Arizona Public Service Company

Subject: Final Report - DER 82-61
A 50.55(e) Reportable Condition Relating to Reactor Coolant
Pump Diffuser Ring Cap Screws May Fail And Damage Pump
File: 84-019-026; D.4.33.2

FINAL REPORT - DER 82-61
DEFICIENCY EVALUATION 50.55(e)
ARIZONA PUBLIC SERVICE COMPANY (APS)
PVNGS UNITS 1, 2, & 3

TITLE: REACTOR COOLANT PUMP DIFFUSER BOLT FAILURE SUMMARY

DIFFUSER/CASING
BOLTED CONNECTION

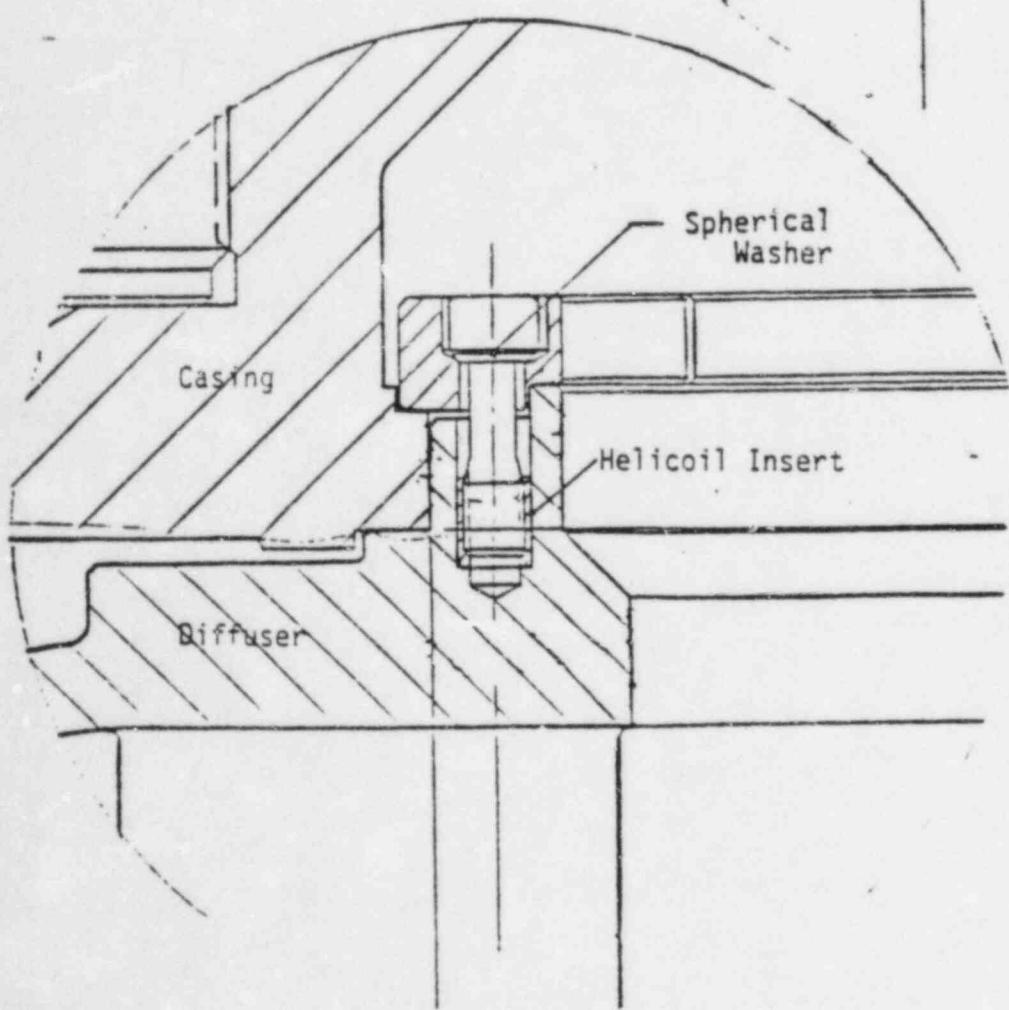
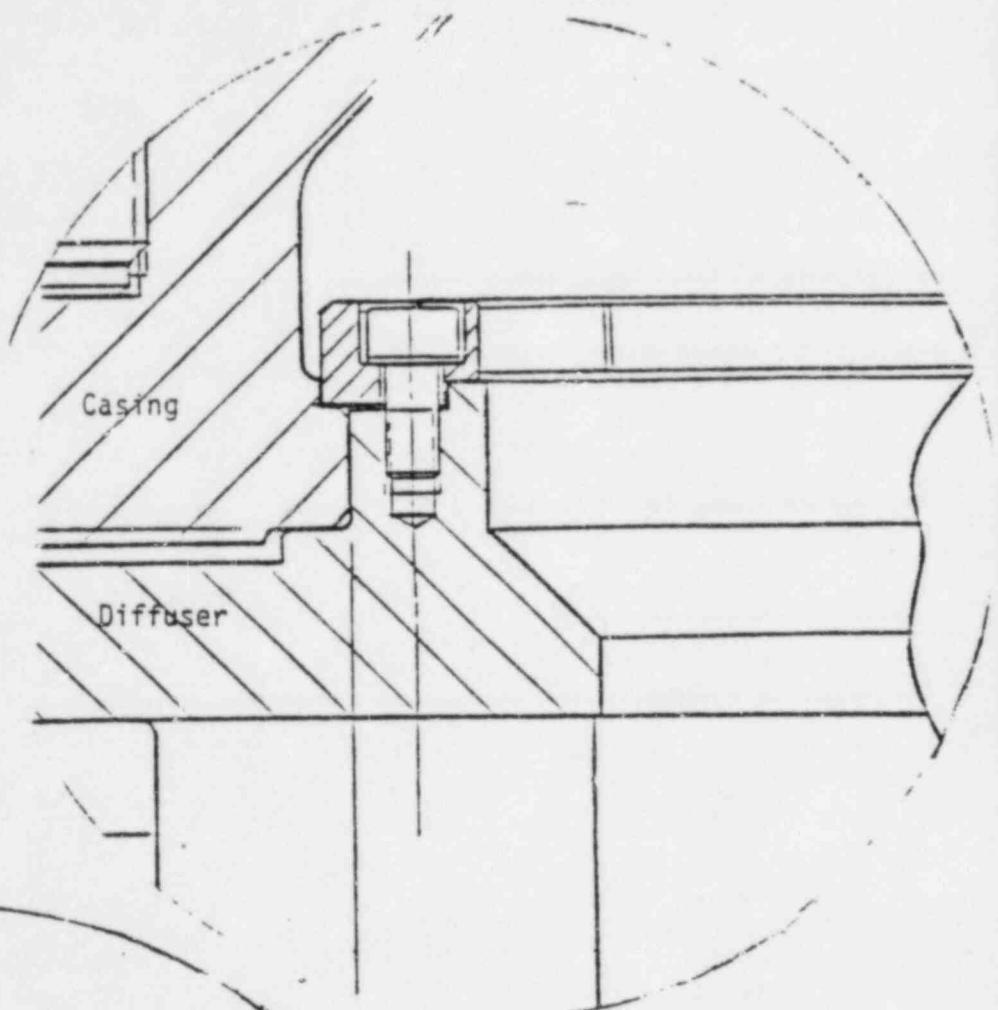
The bolt failure in Reactor Coolant Pump #1 was originally identified as failure due to improper mechanical assembly procedures. Engineering felt, at the time, that a spherical washer, necked down bolt, and a higher strength bolting material would result in a more conservative bolted connection. The original diffuser-to-casing bolting connection is shown in Figure 1. The bolts were M20 x 40 made from ASTM A193-47 Grade B6 material. The re-designed bolts (M20 x 65 Unbrako KS-17 material) are also shown in Figure 1.

DIFFUSER WEDGE ASSEMBLY

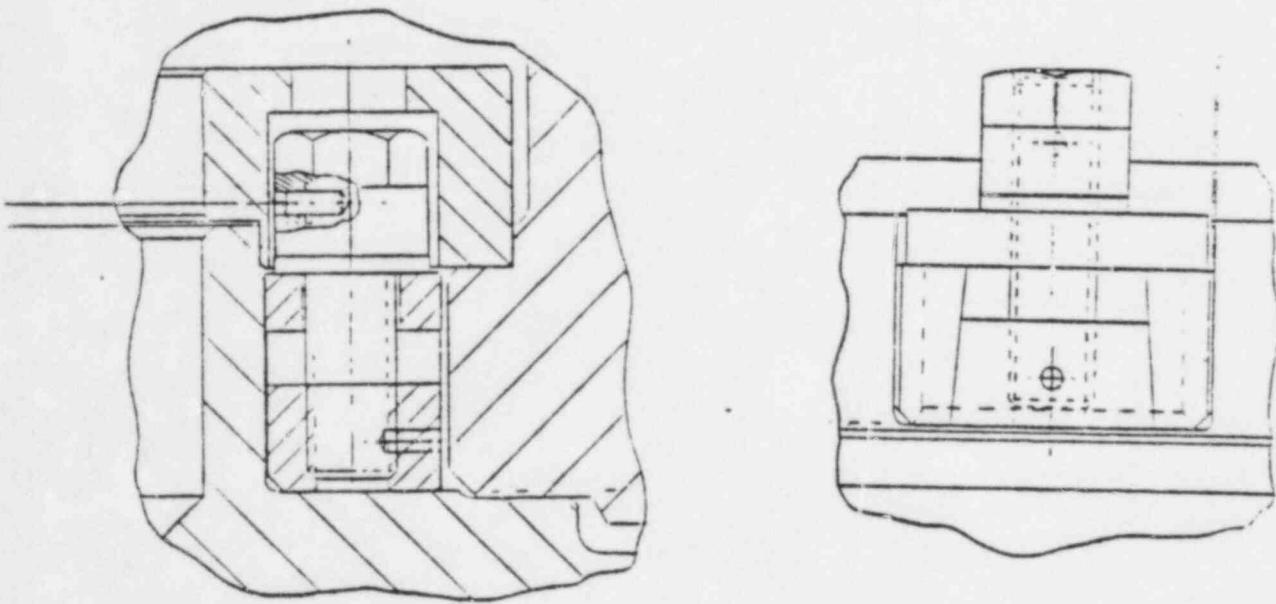
1. Continue to use Type 410 bolting material with a modified heat treatment procedure.
2. Position the five vane diffuser half on the right hand side of the pump casing to minimize the induced stress levels in the bolts.
3. Install diffuser wedges to limit the movement of each diffuser half.
